IN THE DRAWINGS:

REMARKS

The above amendments to the above-captioned application along with the following remarks are being submitted as a full and complete response to the Official Action dated August 11, 2006. In view of the above amendments and the following remarks, the Examiner is respectfully requested to give due consideration to this application, to indicate the allowability of the claims, and to pass this case to issue.

FIG.11C

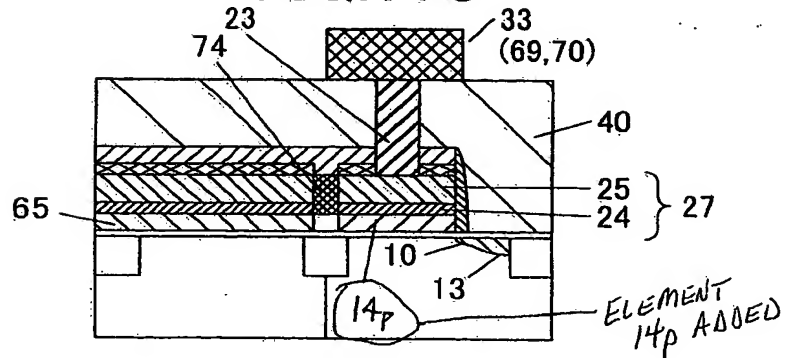
The attached sheet of drawings includes changes to Fig. 11C. This sheet, which includes Fig. 11A-11D, replaces the original sheet including Fig. 11A-11D. In Fig. 11C, numeral "66" has been amended to numeral "14p". An annotated sheet showing the change is also attached. A Letter to the Draftsperson is submitted herewith.

The drawings have been objected to for 1) failing to comply with 37 CFR §1.84(p)(4), because reference characters “14p” and “10p” have both been used to designate p-type region, and 2) failing to comply with 37 CFR §1.84(p)(5), because reference numeral 66 in Figure 11C is not mentioned in the description.

Applicant respectfully submits appropriate amendments have been made to both the drawings and the specification, as requested by the Examiner.
